BIGGS & MATHEWS ENVIRONMENTAL

February 18, 2015

Re: Waste Management Skyline Landfill – Dallas and Ellis Counties
Municipal Solid Waste (MSW) Permit No. 42D
Permit Amendment Application – Supplemental Review Comments
Tracking Nos. 15821429, 16078600, and 18430503; RN100542232/CN603572132

**POTENTIOMETRIC SURFACE
JUNE 2011**

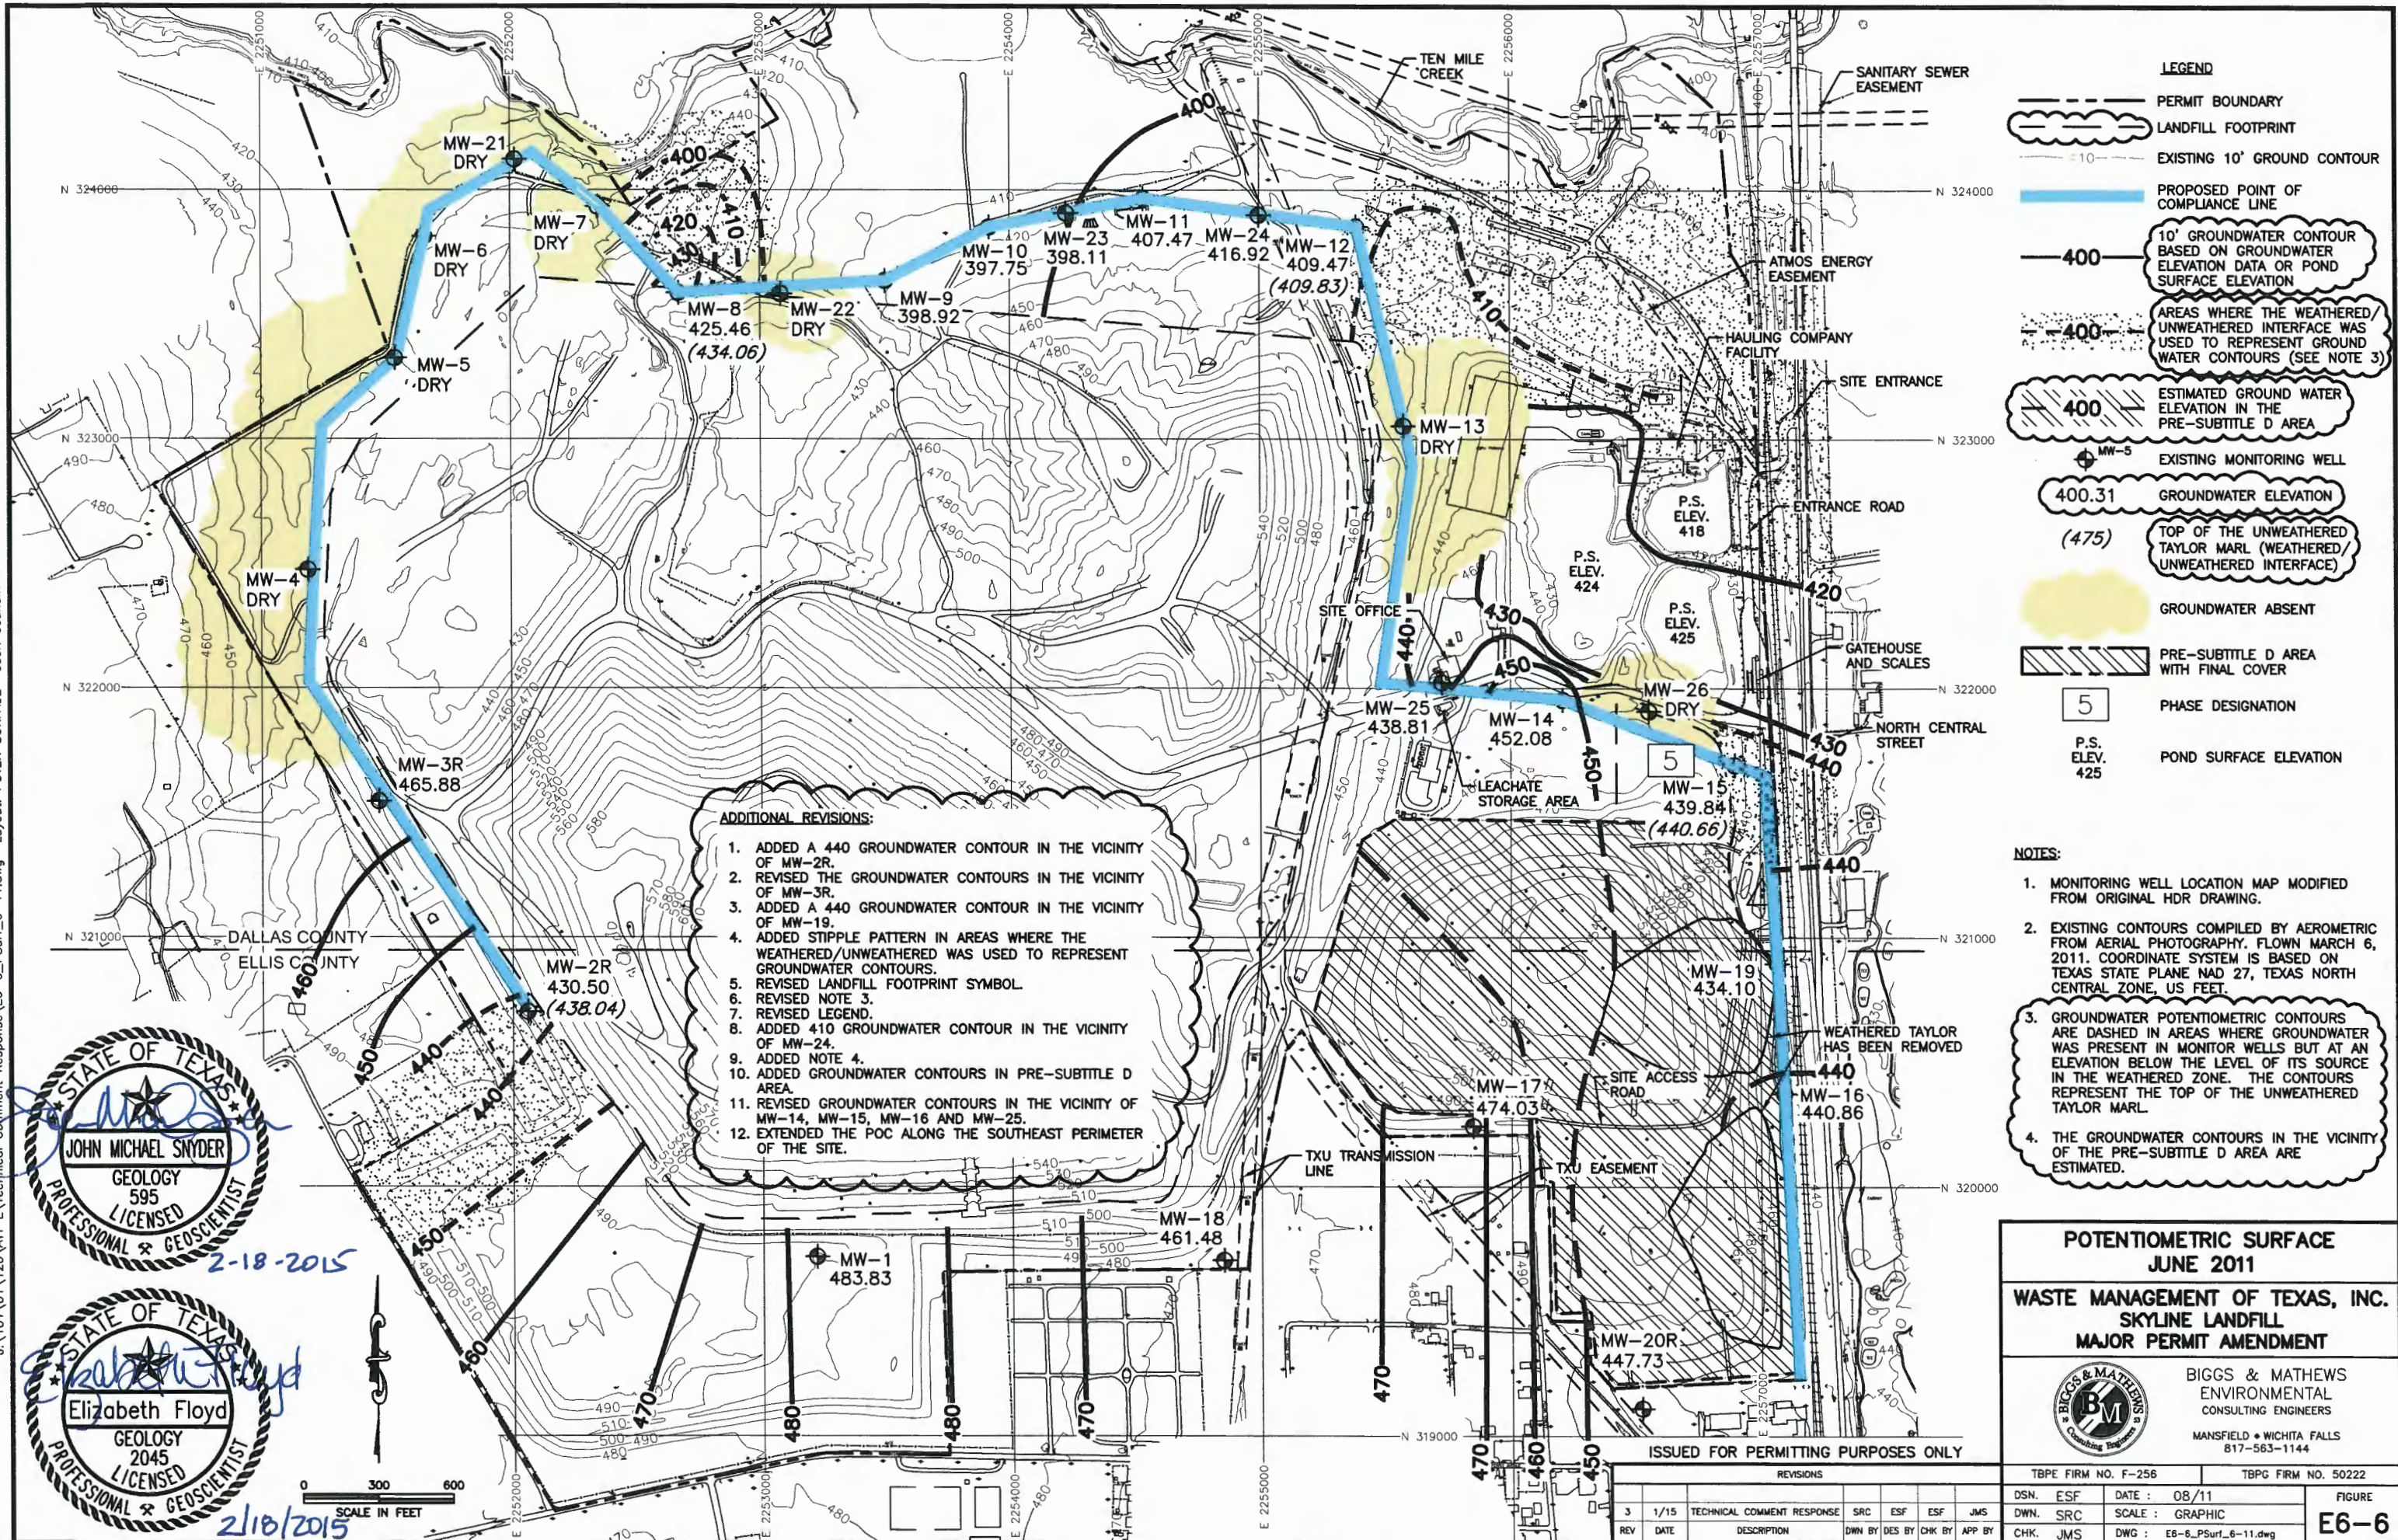
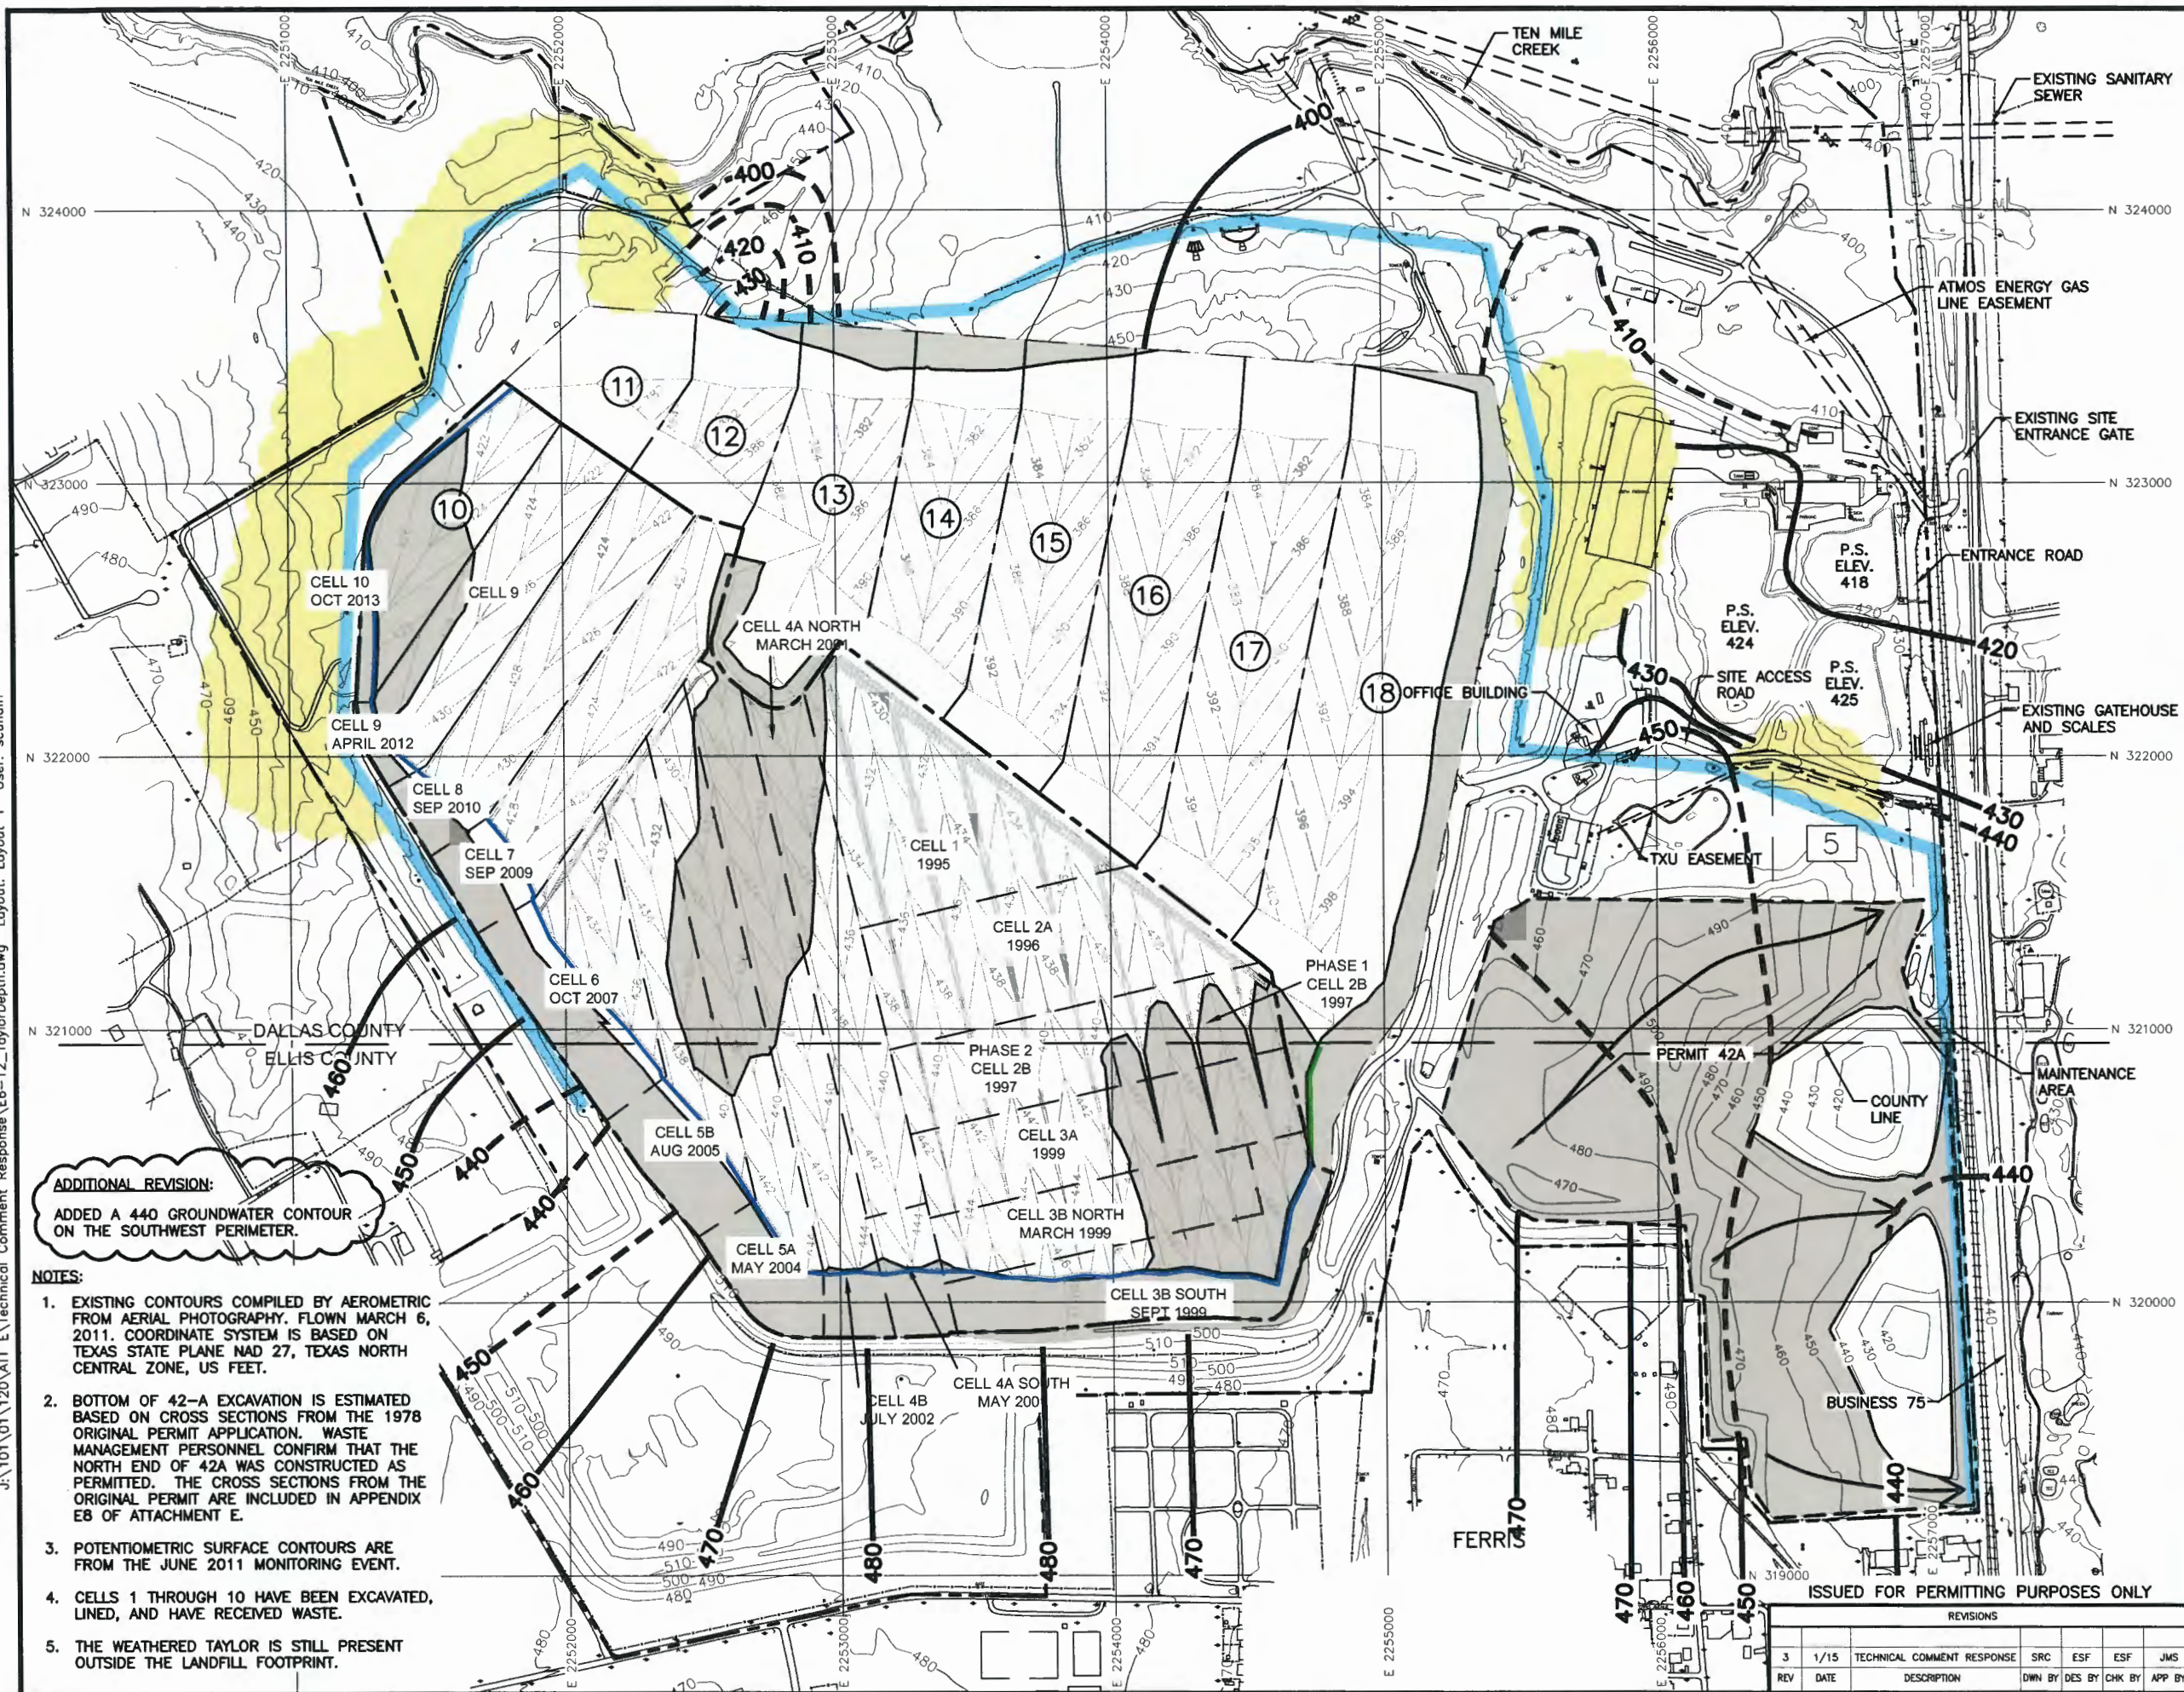
2. Review and clarify the potentiometric surface contours presented on the figures in Appendix E6.

RESPONSE: As we discussed, potentiometric surface contours were revised on Figures E6-1 through E6-6 and E6-12.

- ADDITIONAL REVISIONS:**
1. ADDED A 440 GROUNDWATER CONTOUR IN THE VICINITY OF MW-2R.
 2. REVISED THE GROUNDWATER CONTOURS IN THE VICINITY OF MW-3R.
 3. ADDED A 440 GROUNDWATER CONTOUR IN THE VICINITY OF MW-19.
 4. ADDED STIPPLE PATTERN IN AREAS WHERE THE WEATHERED/UNWEATHERED WAS USED TO REPRESENT GROUNDWATER CONTOURS.
 5. REVISED LANDFILL FOOTPRINT SYMBOL.
 6. REVISED NOTE 3.
 7. REVISED LEGEND.
 8. ADDED 410 GROUNDWATER CONTOUR IN THE VICINITY OF MW-24.
 9. ADDED NOTE 4.
 10. ADDED GROUNDWATER CONTOURS IN PRE-SUBTITLE D AREA.
 11. REVISED GROUNDWATER CONTOURS IN THE VICINITY OF MW-14, MW-15, MW-16 AND MW-25.
 12. EXTENDED THE POC ALONG THE SOUTHEAST PERIMETER OF THE SITE.
